Service Bulletin

Bulletin No.: 24-NA-234

Subject: Front Hood Misadjusted (Re-align), Front Hood Dented When Latched (Lower Front Hood Bumpers and/or Slightly Raise Latch to Remove Appearance of Dents)

Brand:	Model:	Model Year:		Date Breakpoint:		Engine:	Transmission:
		from	to	from	to		
Chevrolet	Malibu	2024	2025	SOP	Built Prior to October 8, 2024	All	All

6751914

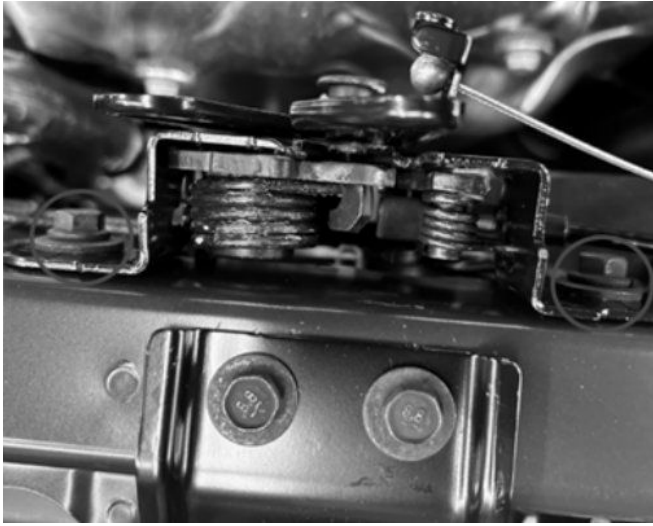
1. Identify the specific area of the dent(s) on the hood.
2. Open the hood to the secondary latch position by pulling and releasing the hood primary latch release cable handle.

3. Observe the specification location identified in step 1 with the hood at the secondary latch position.
4. If the dents are no longer visible, then the hood needs to be adjusted based on the Service Procedure below.
